More Thoughts on Encryption for  
SIEPON

CableLabs

# Encryption Initialization (re Kramer 02/06/2023 pg 2)

# DPoEv2 SEC

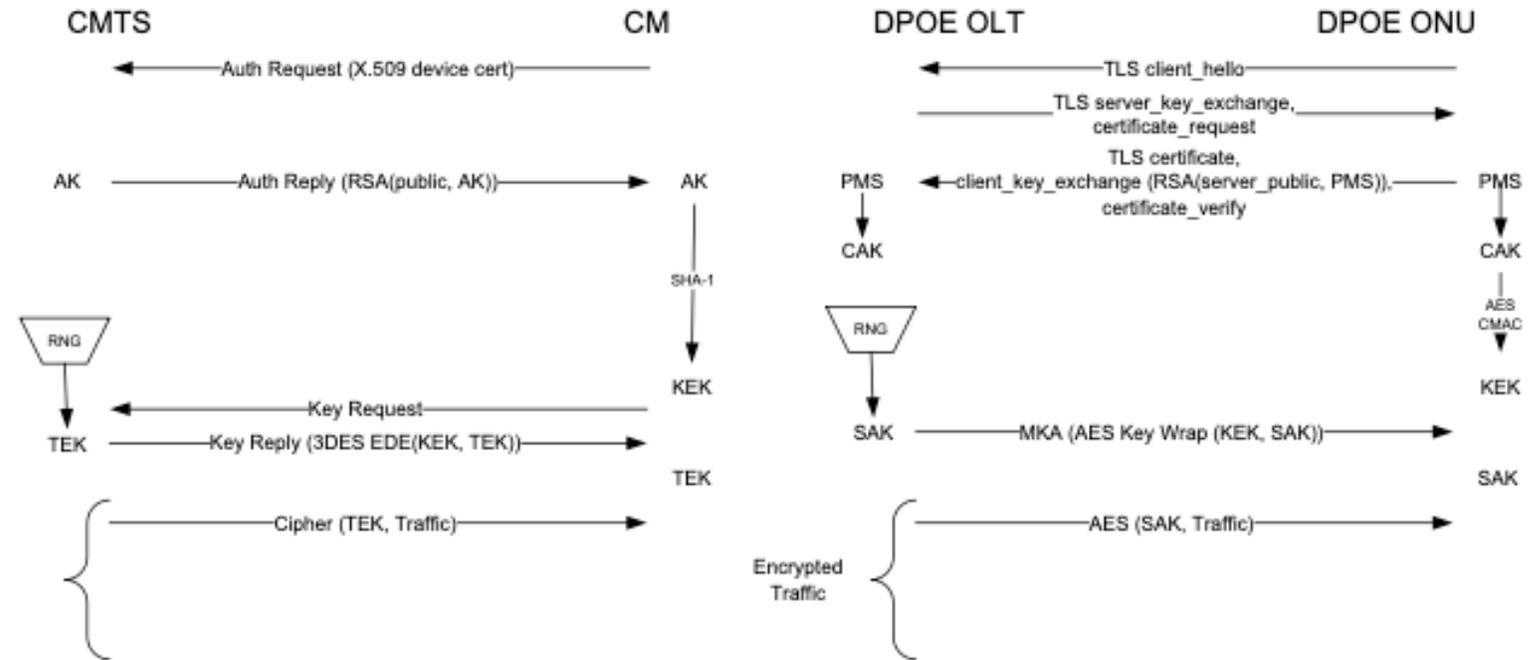
- Little nit – I think both the OLT and ONU derive the KEK and CAK
- SAK key server is implicitly the OLT
